AIA® Document G709™ – 2018

Proposal Request

PROJECT: *(name and address)*
23302901 - HOG2

Architect's Project Number: 23302901
Proposal Request Number: 03

1 ARCHITECTURAL SITE PLAN

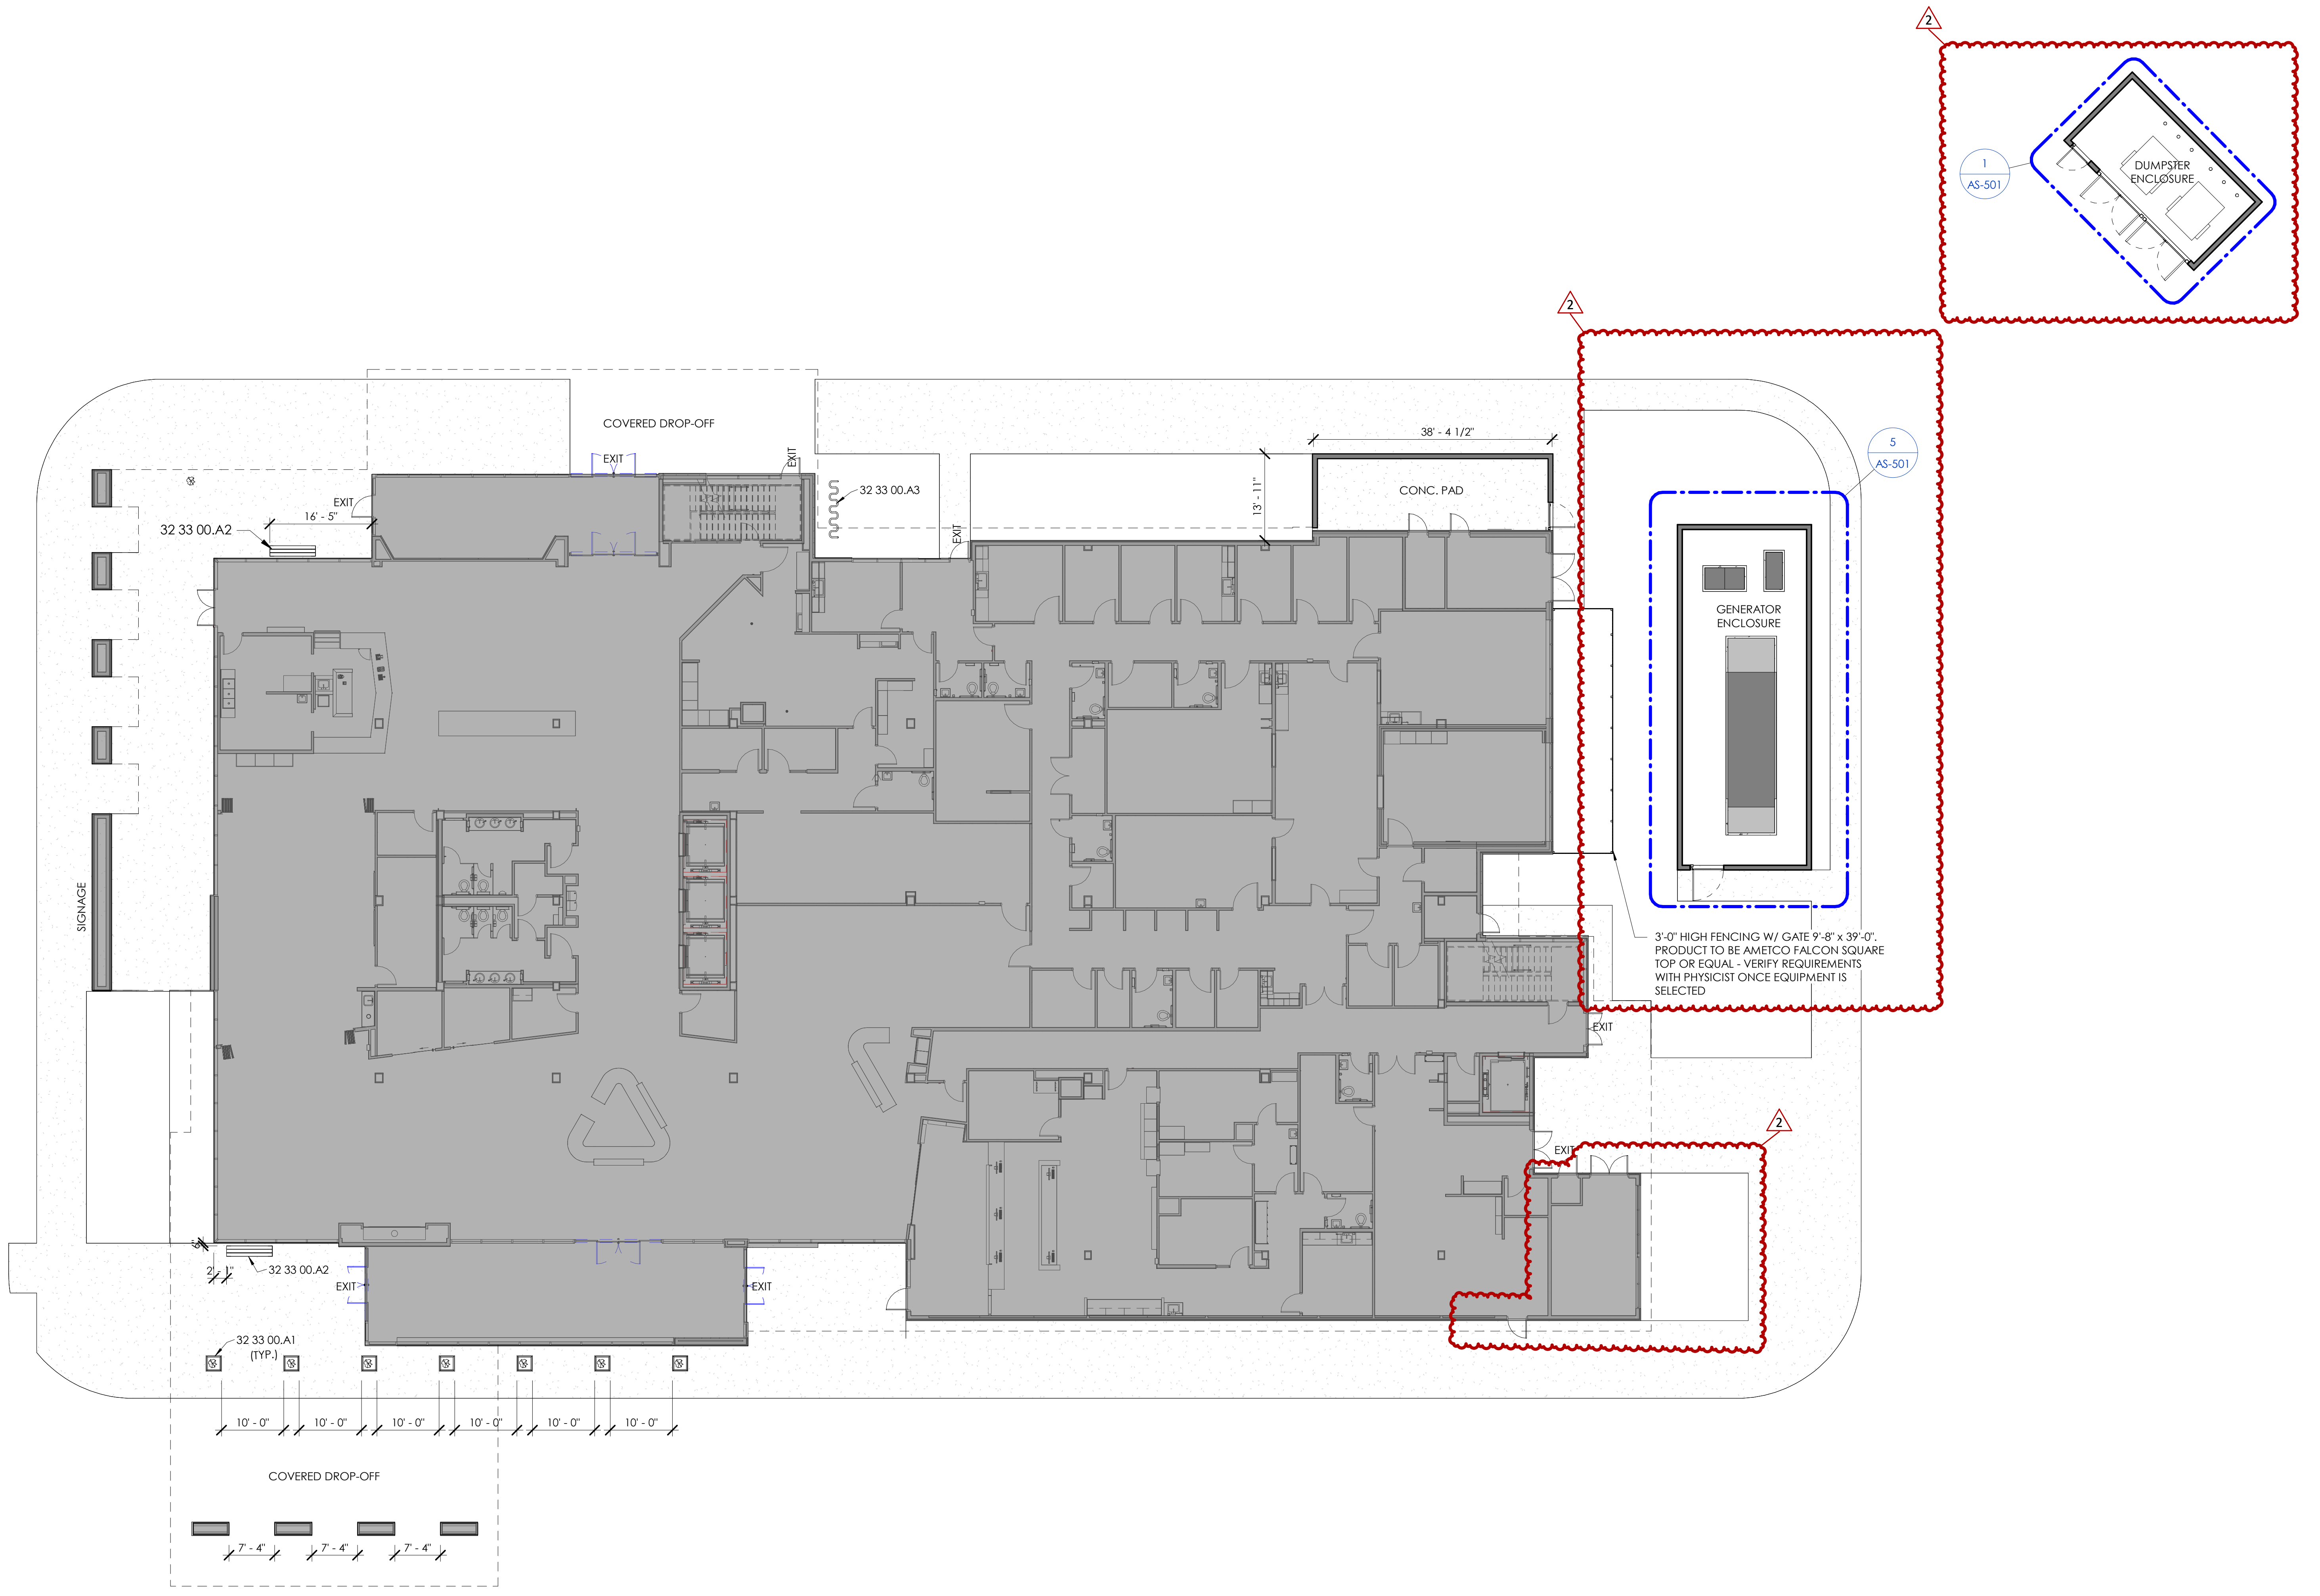
1) See attached AS-101 and AS-501 - revise the site plan to reflect the new emergency generator enclosure, updated trash enclosure, and sidewalks that coordinate with EDG (Civil/Landscape).

1 ES-100 ELECTRICAL SITE PLAN
1" = 50'-0"

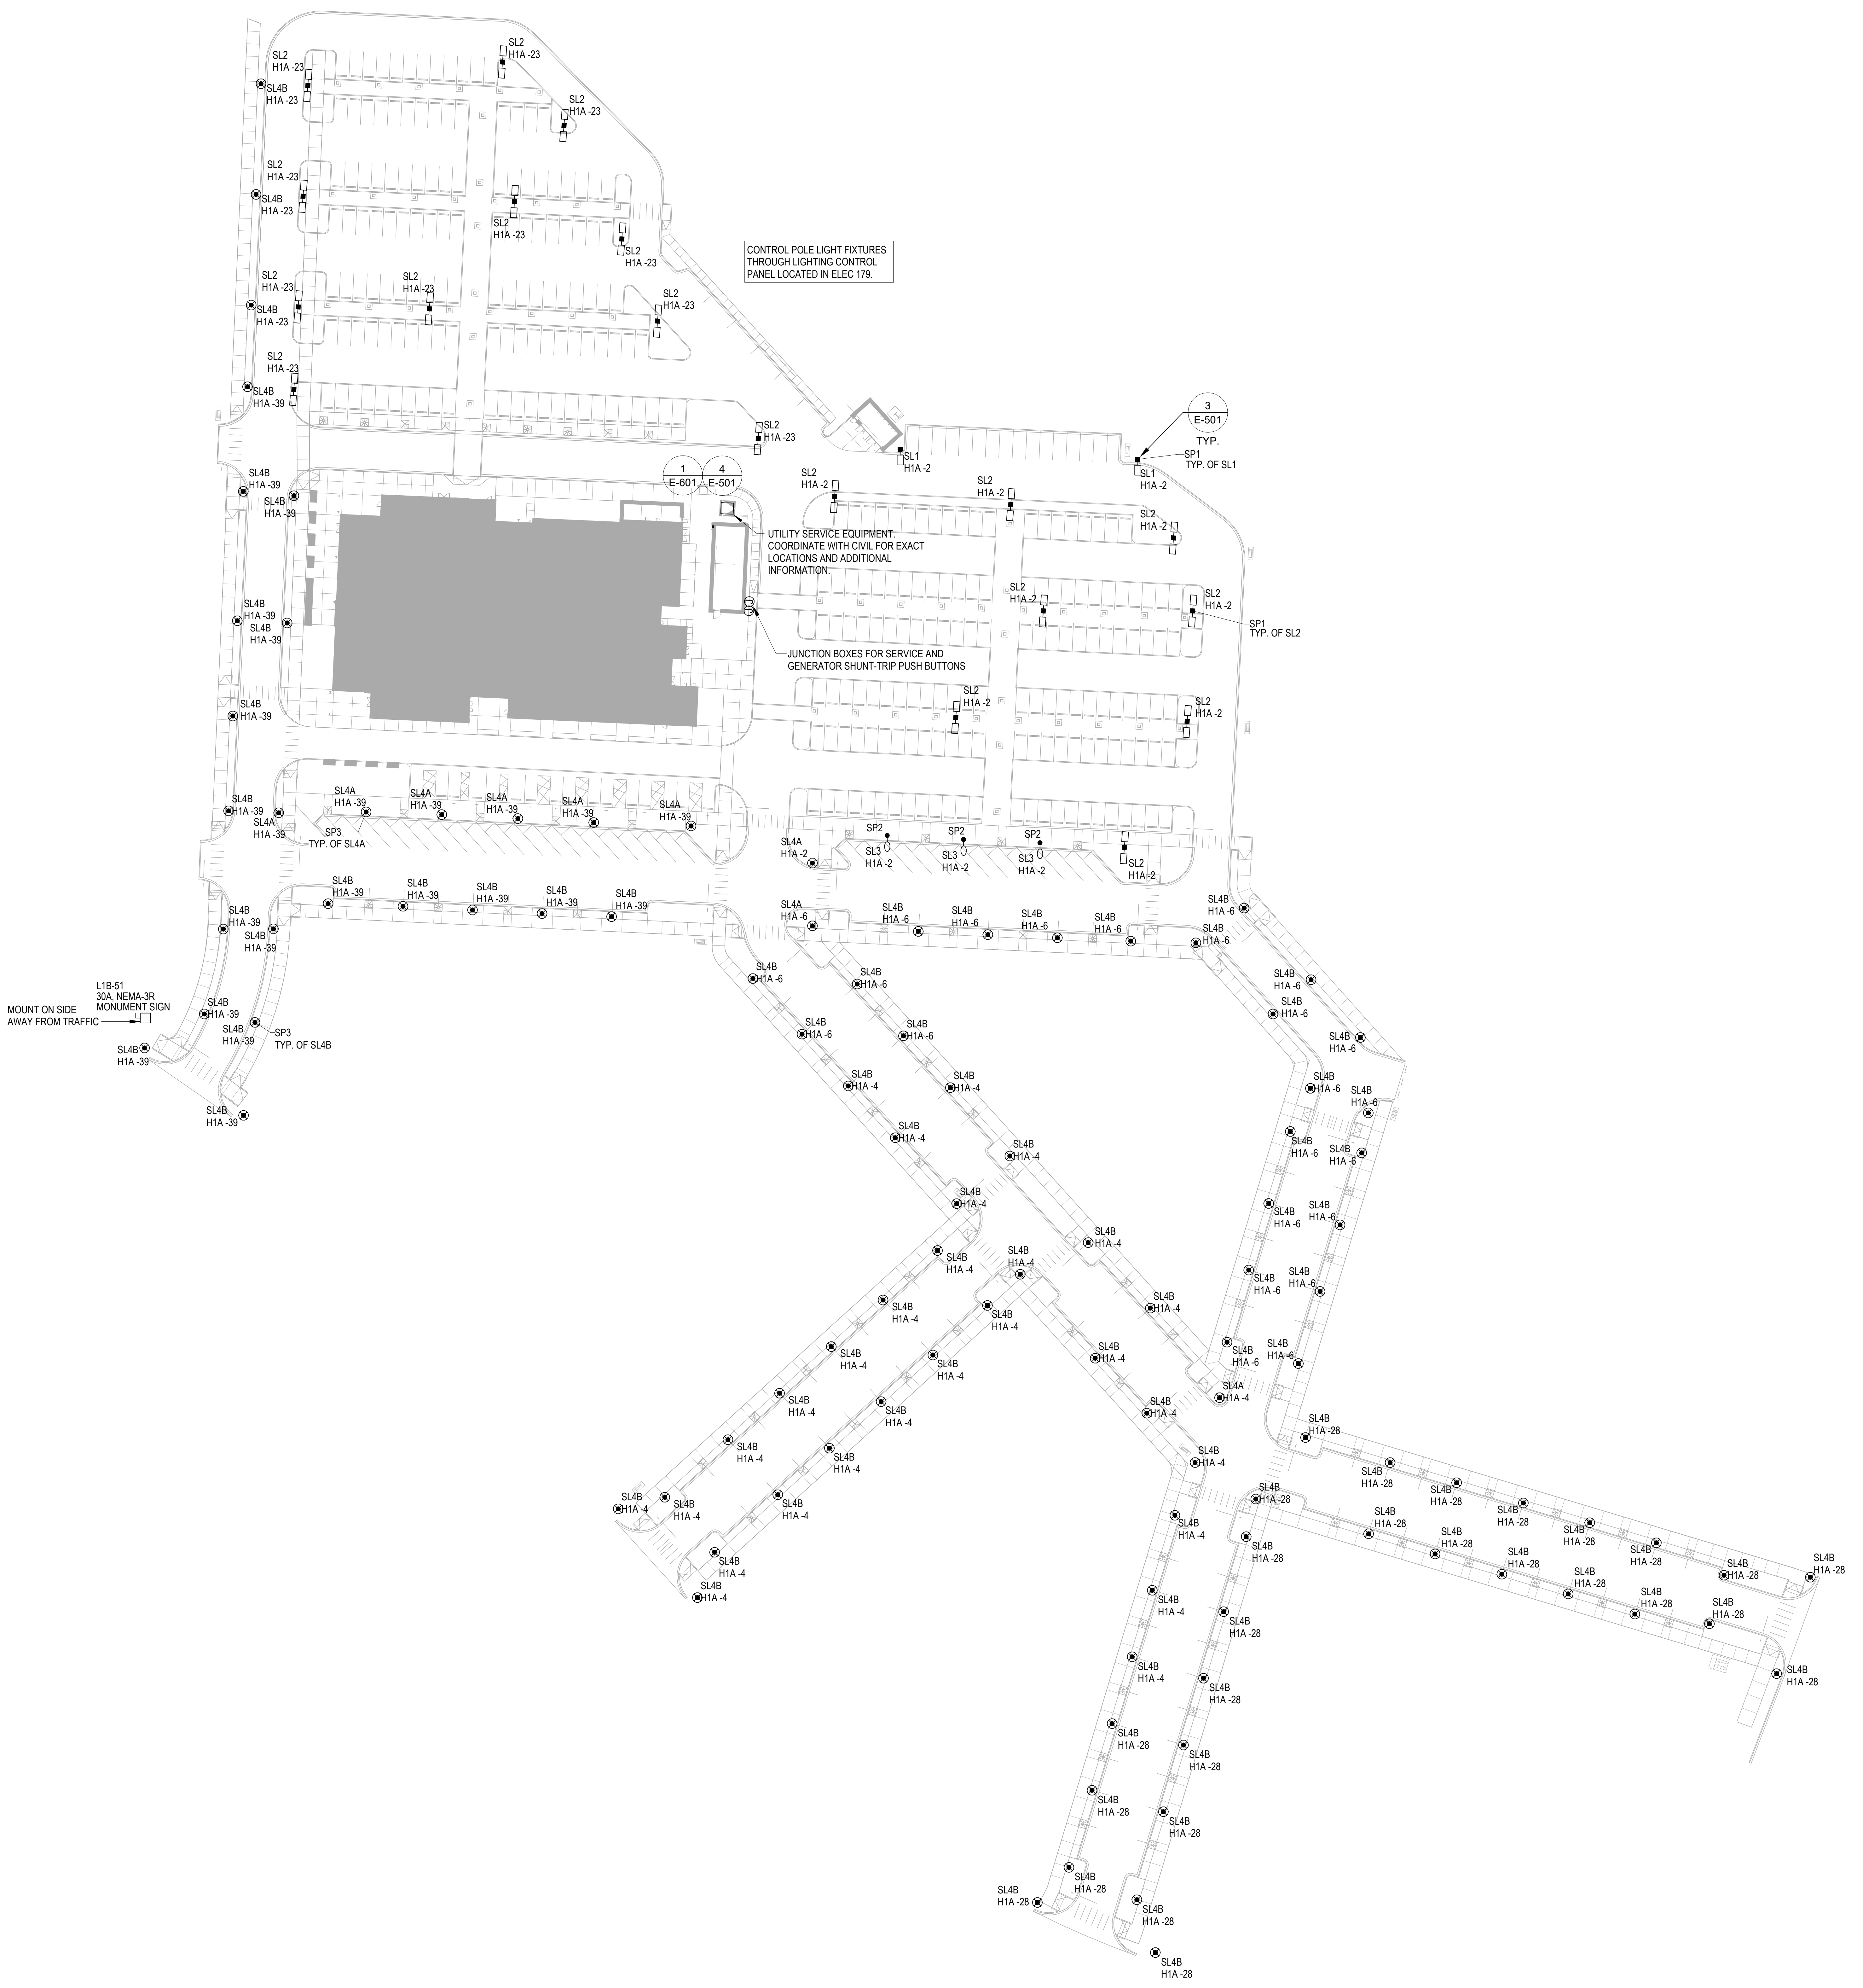
12. ES-100 – ELECTRICAL SITE PLAN
    a. Revised site plan for updated parking lot background.
